## FIELD OBSERVATION REPORT

Lincoln Trail Elementary School, Hardin County Schools, Elizabethtown, KY 201752 -CA8

Report No: 29

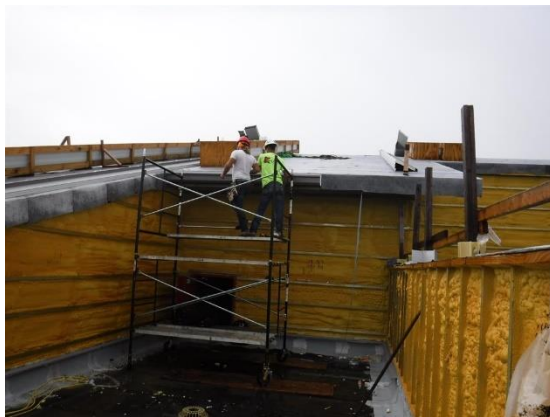
- h) The fiber cement composite panel system is installed on the west side of the Gym. The joints are even, the panel are in plane and are level. Note that the vapor barrier was extended over the exterior wall above the Kitchen without applying the intumescent fire proofing. This must be applied before proceeding with this area. Also note that the concrete exterior exit stair for the Gym has been construction.

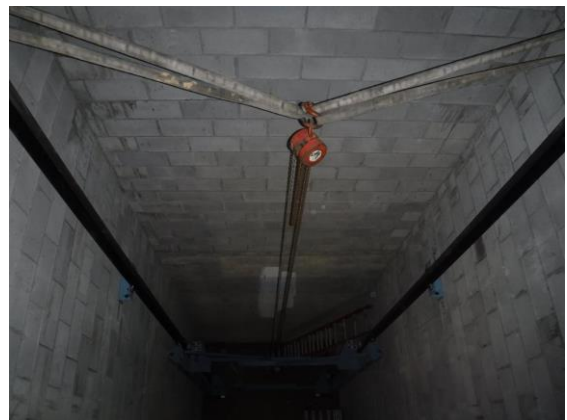
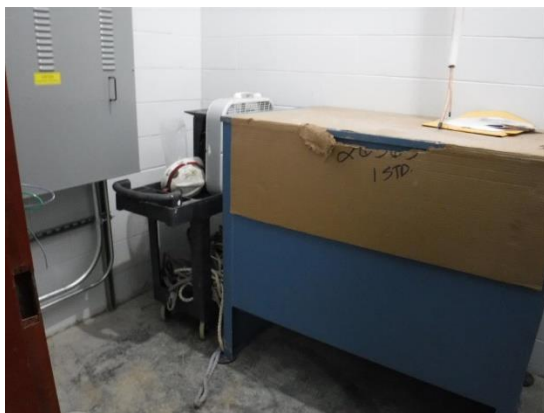
- w) The rear entrance is not installed leaving this area open to the elements.

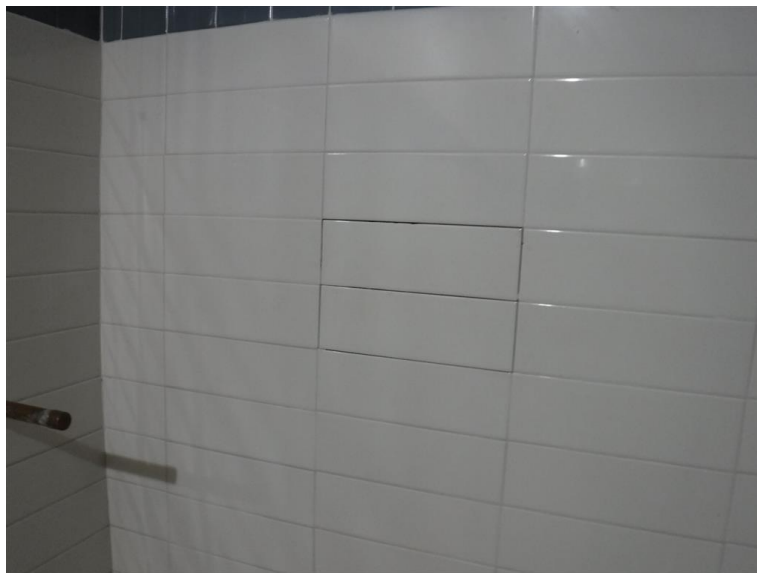
- cc) Although the wall tile walls look better after some of the tiles have been replaced, there are still areas that need attention.

- ee) The entry to this toilet group and typical wall in the toilets still have tiles that are noticeably out of plane. These out of plane tiles need to be replaced.
